MIL-R-39016/34E
AMENDMENT 3
15 February 2002
SUPERSEDING
AMENDMENT 2
29 March 1993

PERFORMANCE SPECIFICATION SHEET

RELAYS, ELECTROMAGNETIC, DPDT, LOW LEVEL TO 1.0 AMPERE,
(0.100-INCH TERMINAL SPACING)

FIGURE 1. Outline and dimensions."

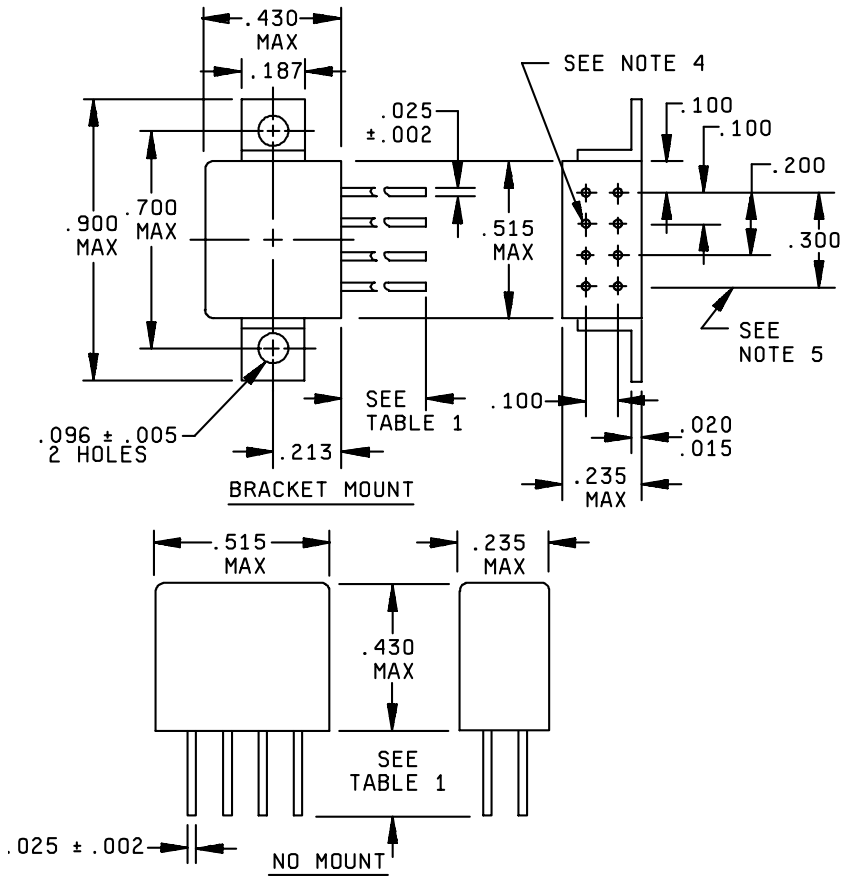
FIGURE 1, delete in its entirety and substitute:

FIGURE 1, tab mount, delete ".505 MAX" and substitute ".515 MAX".
